**9/11 PENTAGON MEMORIAL  
VISITOR EDUCATION CENTER**  
ARLINGTON, VIRGINIA

CFA CONCEPTUAL REVIEW: June 15th, 2023

NCPC CONCEPTUAL REVIEW: July 6th, 2023

**PRIOR DESIGN (PRESENTED TO CFA IN MAY 2022)**

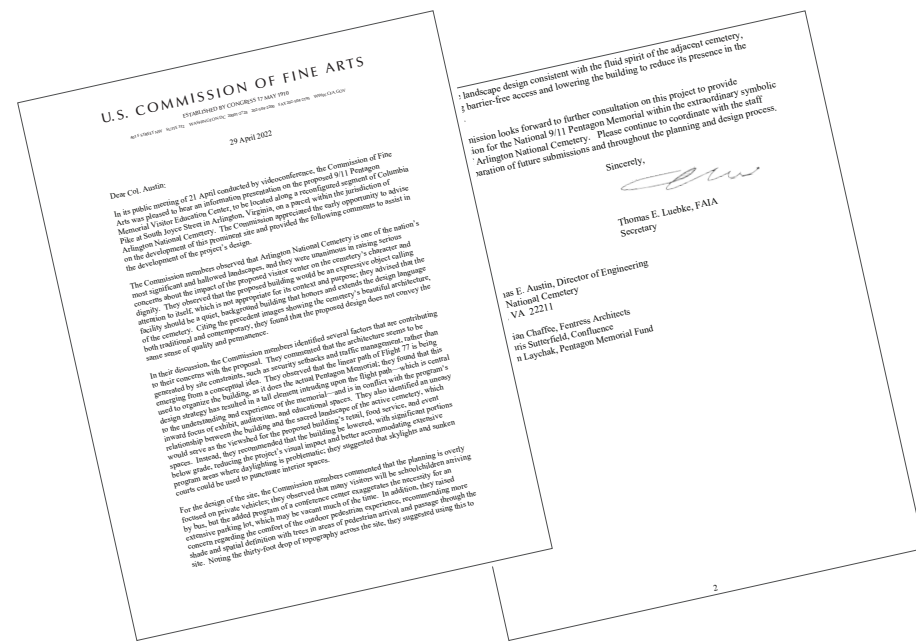
- Concern about contextual appropriateness — the “expressiveness” of the proposed VEC conflicts with the “character and dignity” of Arlington National Cemetery. The VEC should “honor the design language” of the Cemetery.
- Concern about the height of the VEC, particularly the tall lobby volume. The VEC should be lowered.
- Concern about the “uneasy relationship” between the “sacred landscape” of the cemetery and the VEC’s proposed retail, cafe, and event spaces — which overlook ANC grounds.
- Concern that the site design is “overly focused on private vehicles” — recommending more focus on site design that is more consistent with surrounding context. The VEC should “address the comfort of the outdoor pedestrian experience, recommending more shade and spatial definition with trees in areas of pedestrian arrival and passage through the site.”
